UNITED NUCLEAR CORPORATION

December 14, 1964

UNITED NUCLEAR CORPORATION
Fuels Recovery Plant, Wood River Junction, Rhode Island

AMENDMENT TO SPECIAL NUCLEAR MATERIAL LICENSE 777

TOWER 1st FLOOR

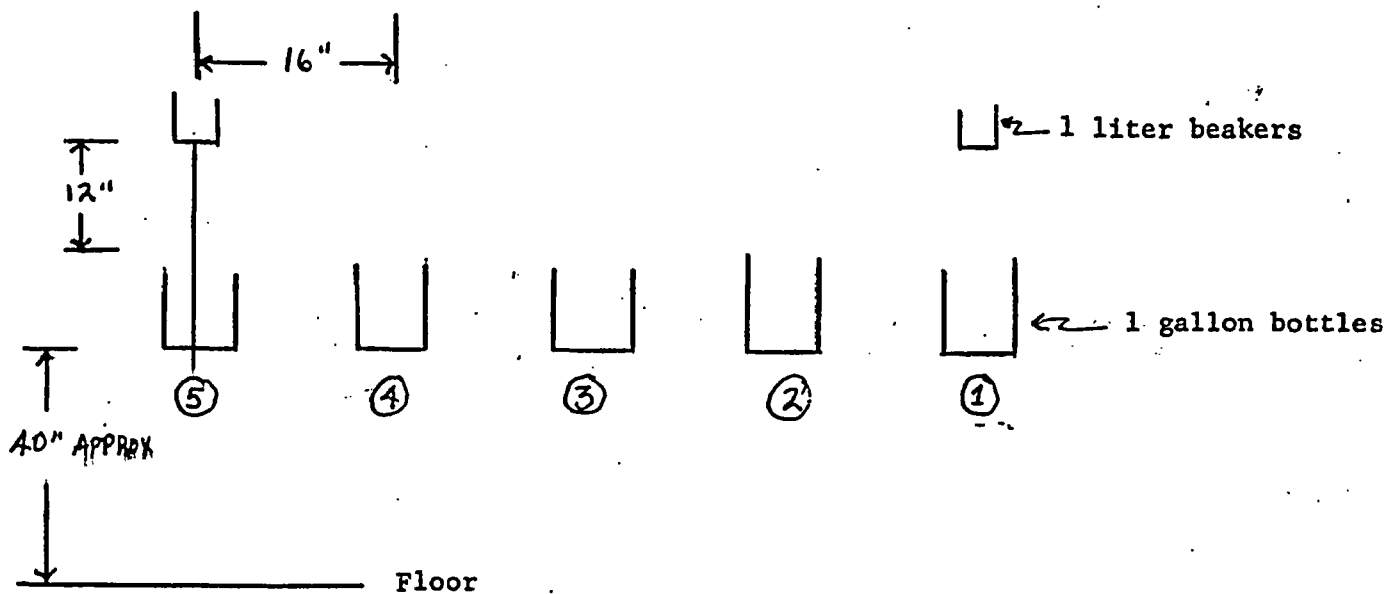
Your review and approval of the attached sketch and nuclear safety calculations for an additional permanent storage area in the Fuels Recovery Plant is requested. Provision has been made for the storage of 5 1-gallon jars on the west wall of the column room. These jars are on 16" horizontal centers 40" above the floor. Above the end jars (positions 1 & 5) will be storage space for a 1-liter beaker 56" from the floor. These jars will be used to collect solutions that have been drawn off at sample points from the extraction columns.

Array is less reactive than approved bunker storage. Conservatively assuming each combination of bottle and beaker is 6" diameter cylinder 30" high, Ω contribution at most reactive column (1-C-7) is:

Cylinder #	Surf to 1-C-7	σ	λ	Ω fract (K-1478 fig 111-3)
1	18"	3	5	.022
2	22.7"	3.78		.017
3	34.3"	5.72		.0088
4	48.3"	8.05		.0048
5	63.2"	10.5		.0032

= .0558 = 0.7 Steradians
contribution
to 1-C-7

AMENDMENT TO SPECIAL NUCLEAR MATERIAL LICENSE 777

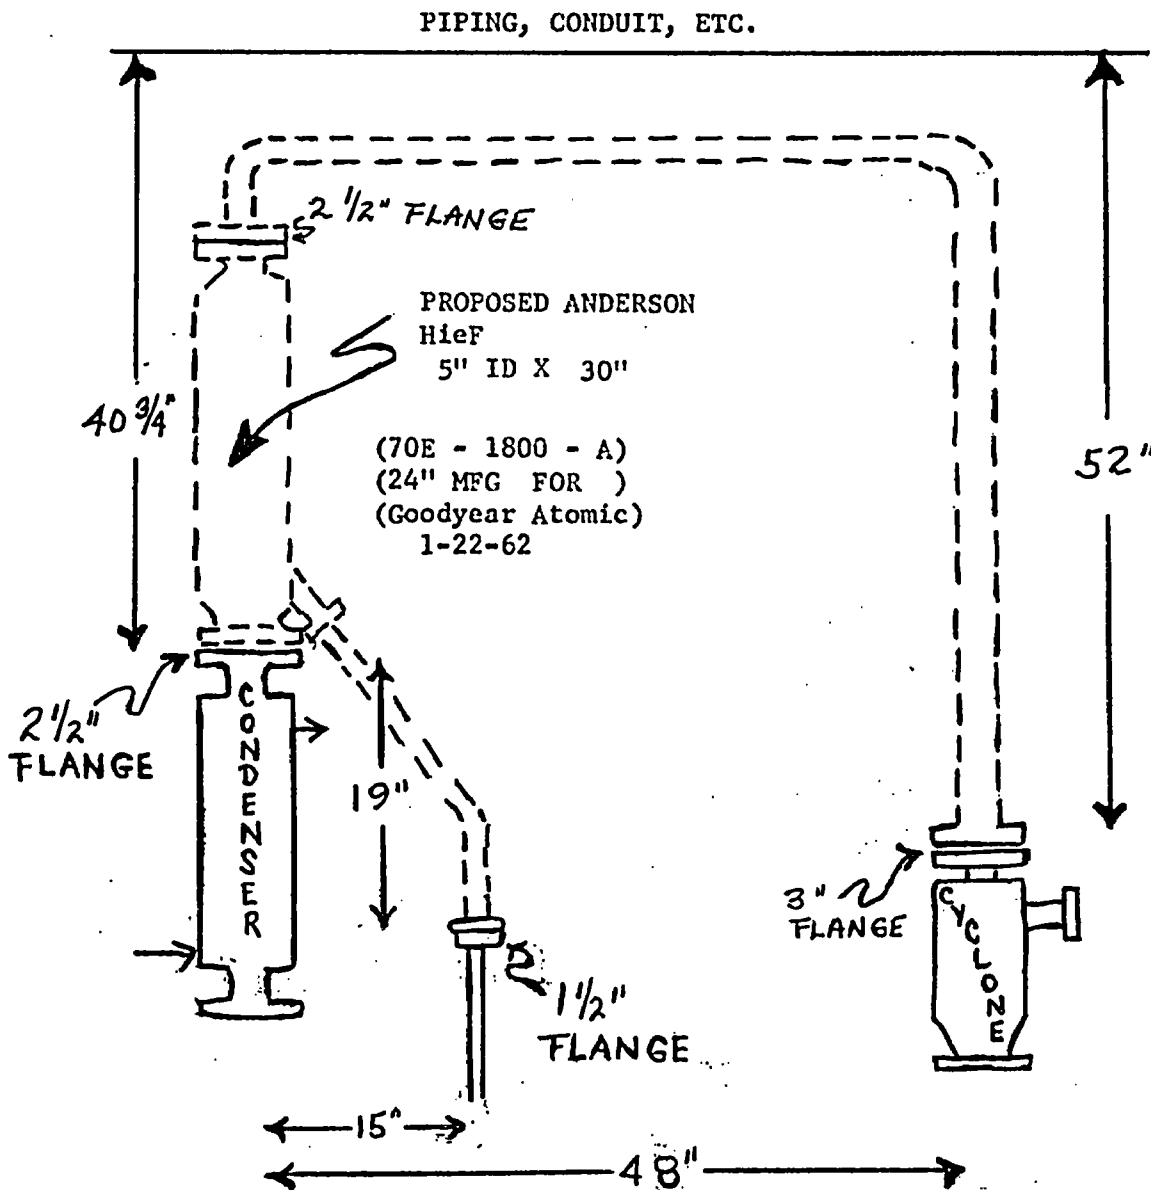
Also attached is a sketch showing the proposed replacement of the present 10" diam. Raschig Ring filled separators with a 5" diam. section.
